Attached is a copy of a report dated February 17, 1988, from the Federal Emergency Agency (FEMA) evaluation of the Waterford 3 Steam Electric Station alert and notification system. The FEMA representatives conducted a system engineering design review and a telephone survey of persons living in the vicinity of the Waterford 3 site. The attached document titled "Waterford 3 Steam Electric Station Site Specific Offsite Radiological Emergency Preparedness Alert And Notification System Quality Assurance Verification " concluded that there was reasonable assurance that the system was adequate to promptly alert and notify the public in the event of a radiological emergency at the site. The Honorable Buddy Roemer, Governor of Louisiana, has been advised of the approval.

The Federal Emergency Management Agency (FEMA) has completed an analysis of the prompt alert and notification system for the Waterford III Steam Electric Station located in Taft, Louisiana. This review has been completed pursuant to Title 44 CFR, Part 350; selected evaluative criteria and Appendix 3 in NUREG-0654/FEMA-REP-1, Revision 1; and FEMA-REP-10, the "Guide for the Evaluation of Alert and Notification Systems for Nu

COMPARATIVE RESULTS, RELATIVELY FLAT TERRAIN (WS3000 SIREN)

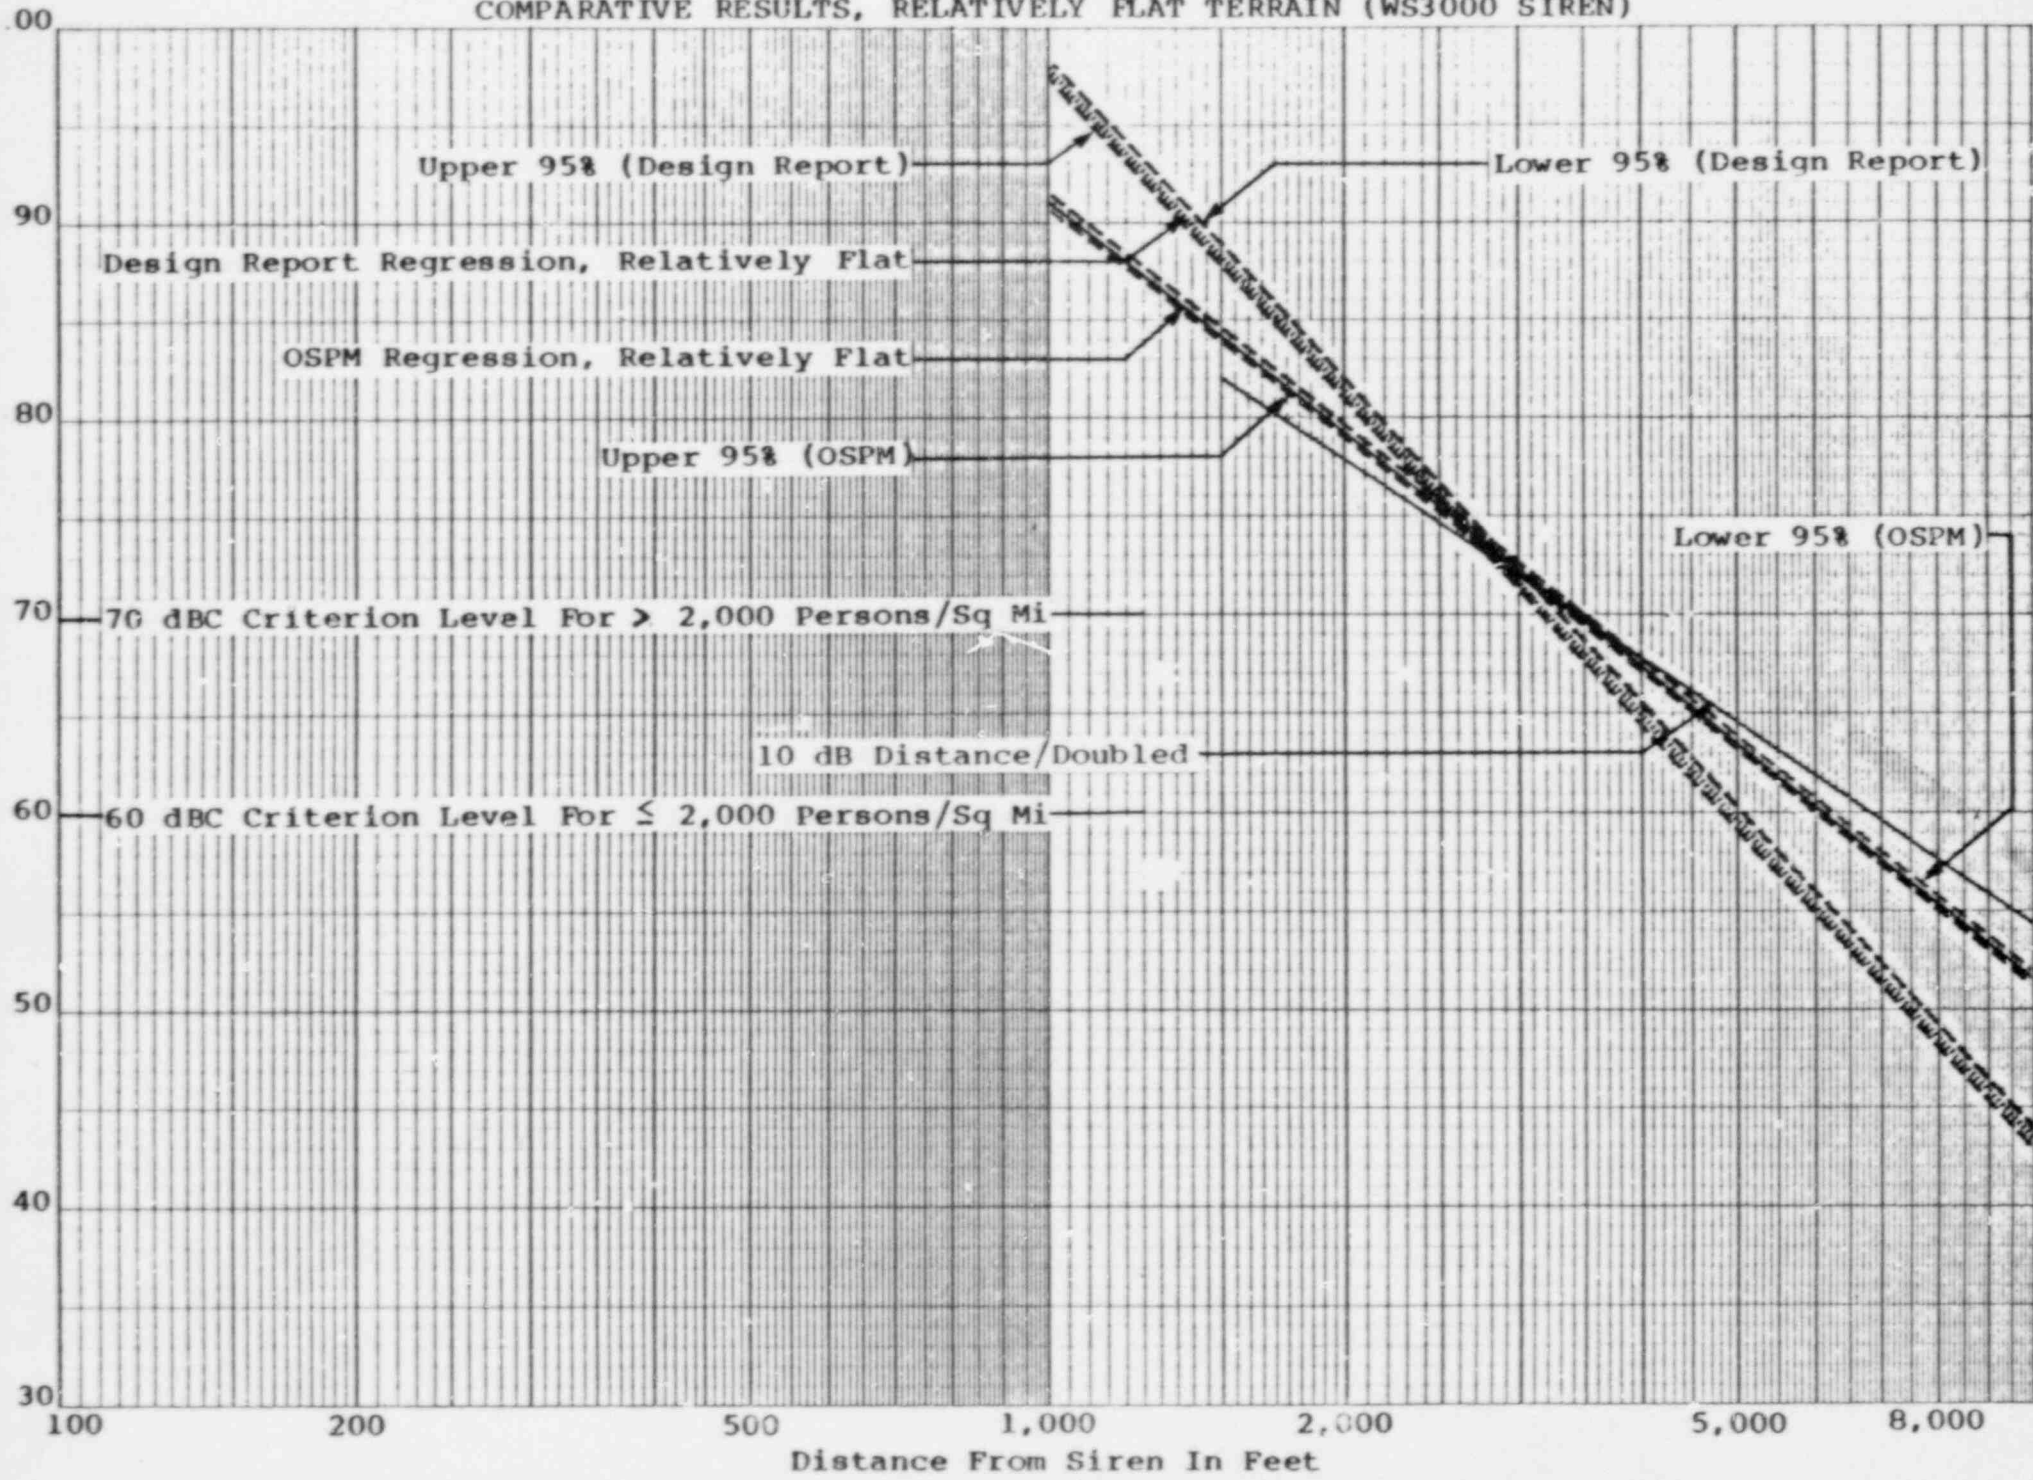
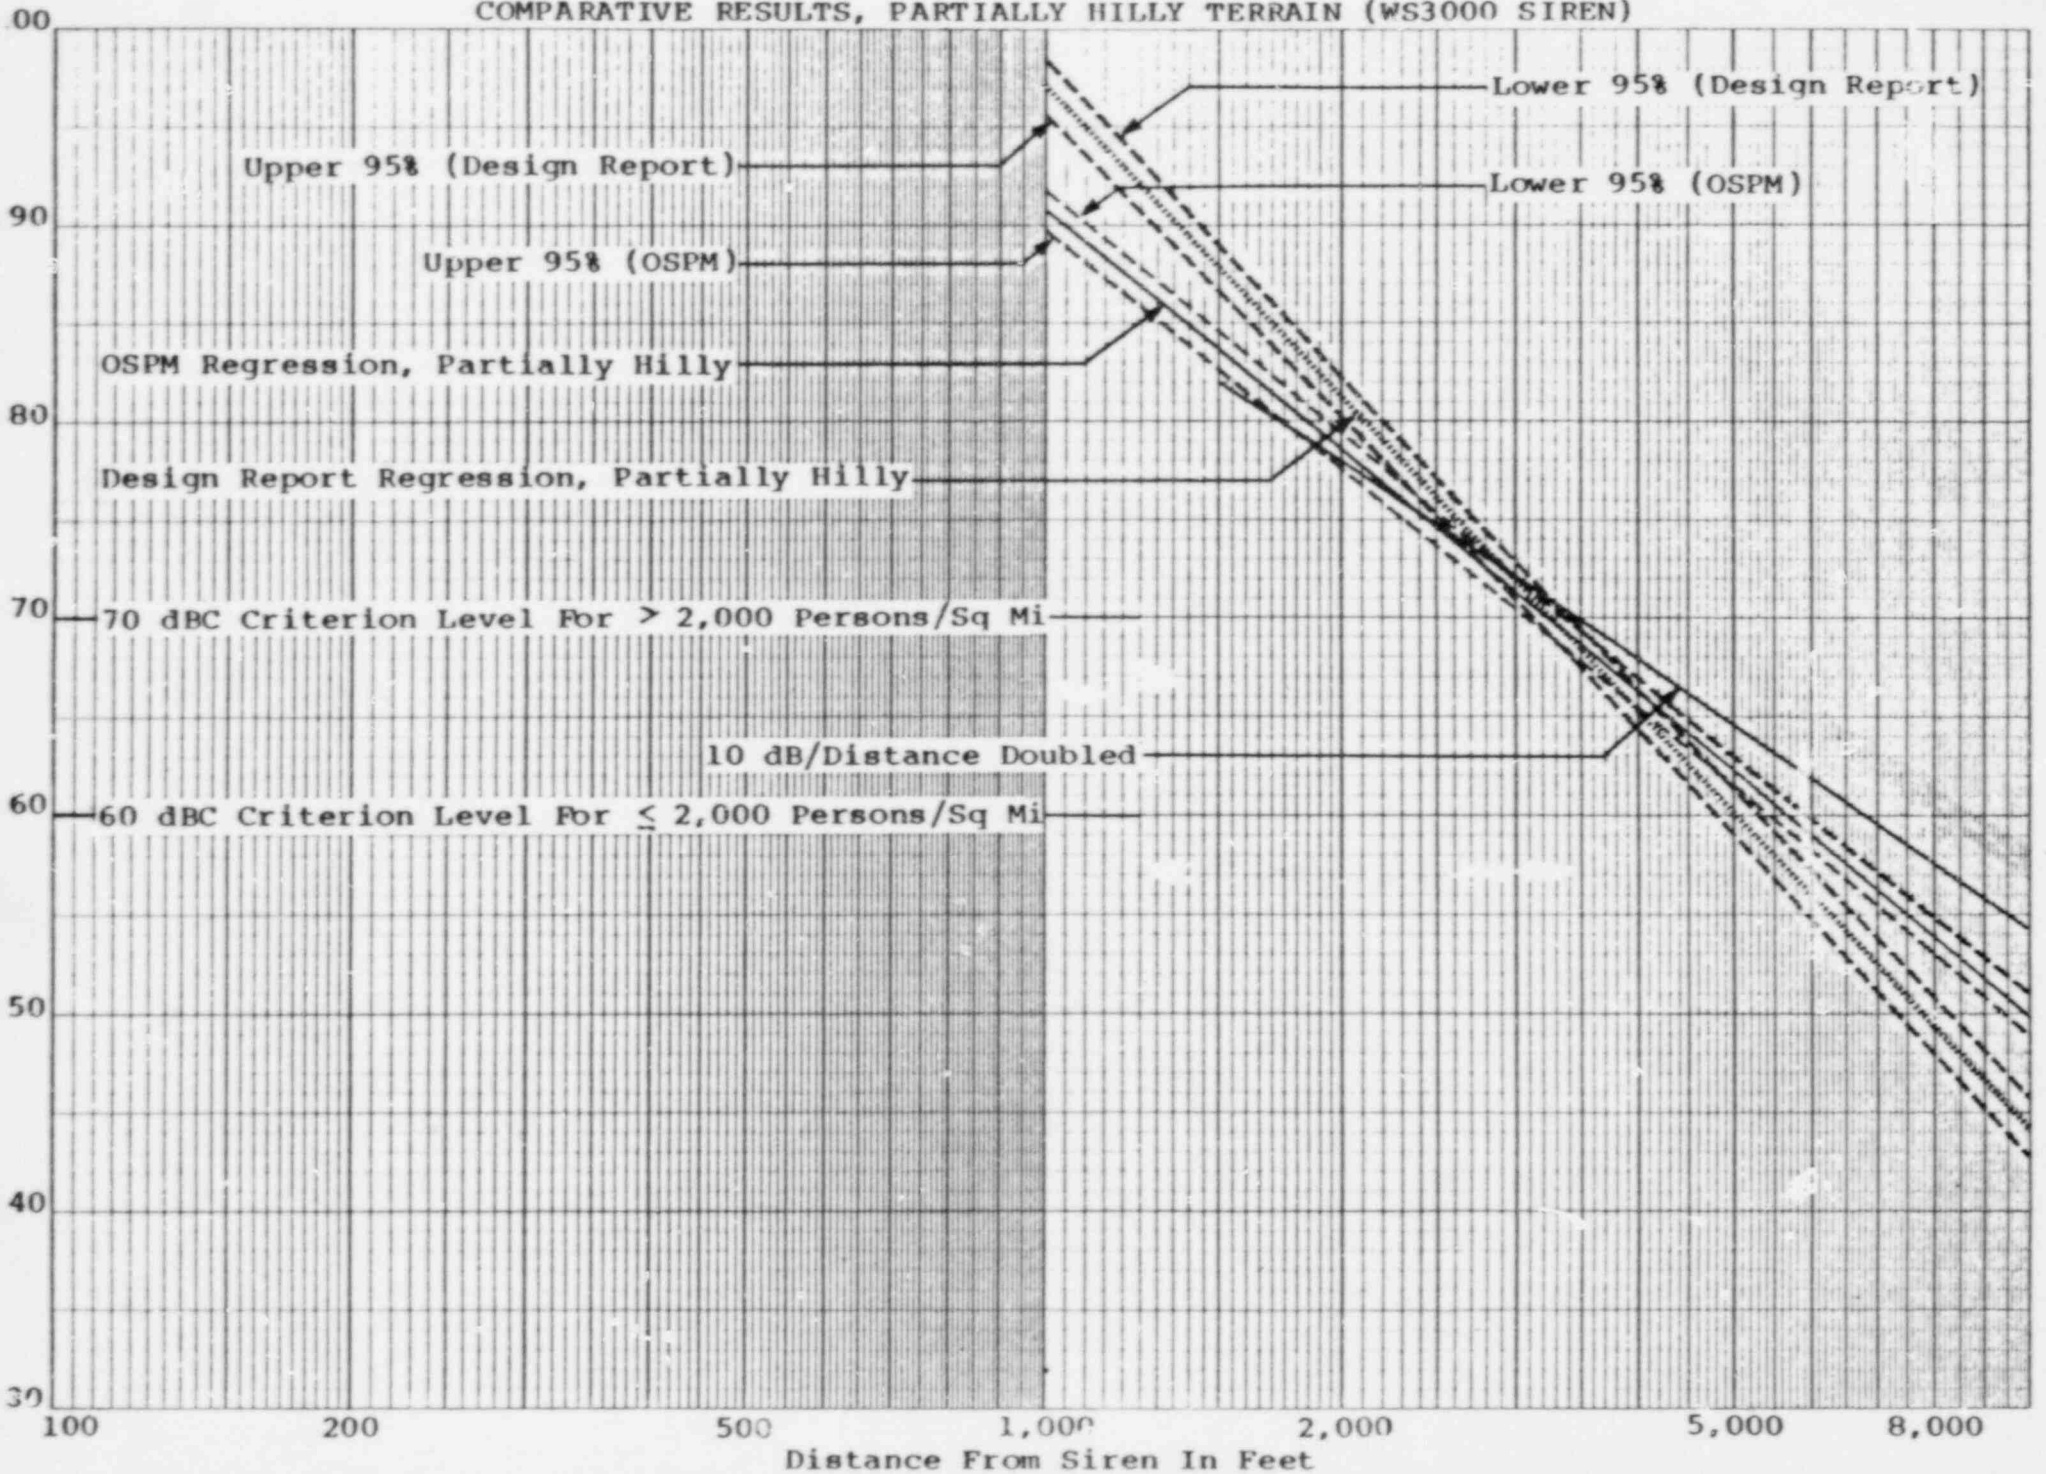
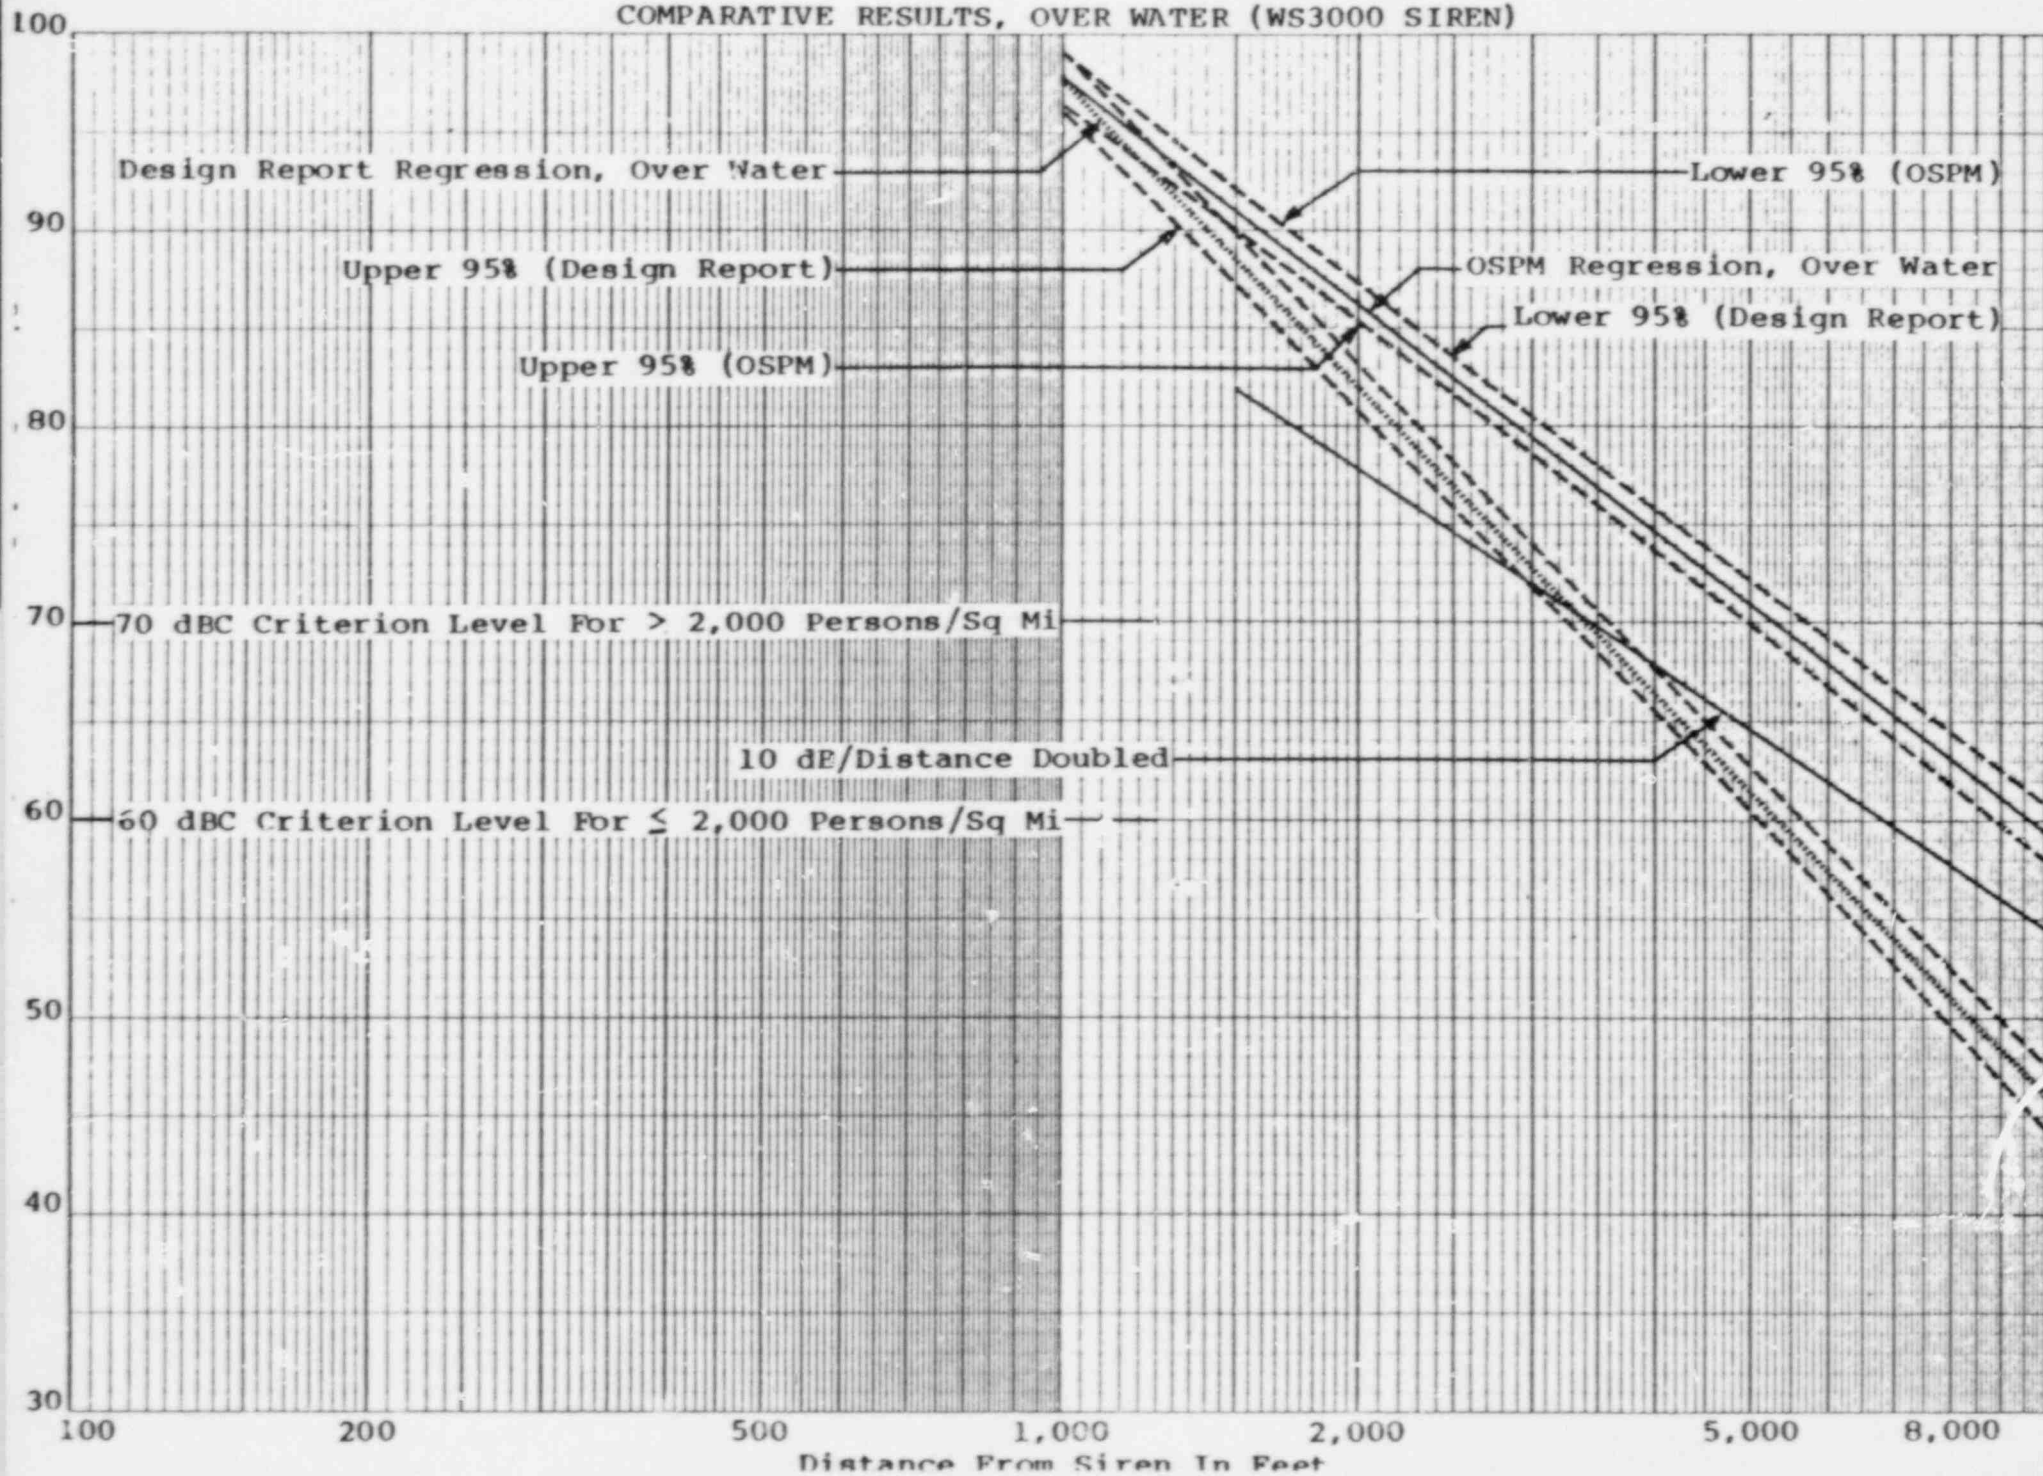
Figures 3 through 6 of this report depict the regressions of OSPM predictions and the Design Report's predictions, along with the 10 dB loss per distance doubled attenuation rate, for each of the four categories. Some general comparative observations can be made. First, the regressed ranges for 70 and 60 dBC based on the Design Report's data are almost identical with those of OSPM predictions over the rolling and flat terrain categories, which are the predominant terrain types in the area. The linearized attenuation rate within the range of 1,000 to 10,000 ft is approximately 12 dB for OSPM results and 15 dB for Design Report results, both substantially higher than the 10 dB per distance doubling rate. This is largely due to the relatively high operating frequency (800 Hz) of the WS-3000 sirens which results in much higher air absorption losses than anticipated by the 10 dB rule (which is applicable to sirens operating at around 500 Hz in the absence of special conditions). Second, the OSPM results show much larger 70 and 60 dBC ranges for propagation paths over water, as expected. Last, the 60 and 70 dBC ranges estimated by the licensee are liberal over the shadow zone category.
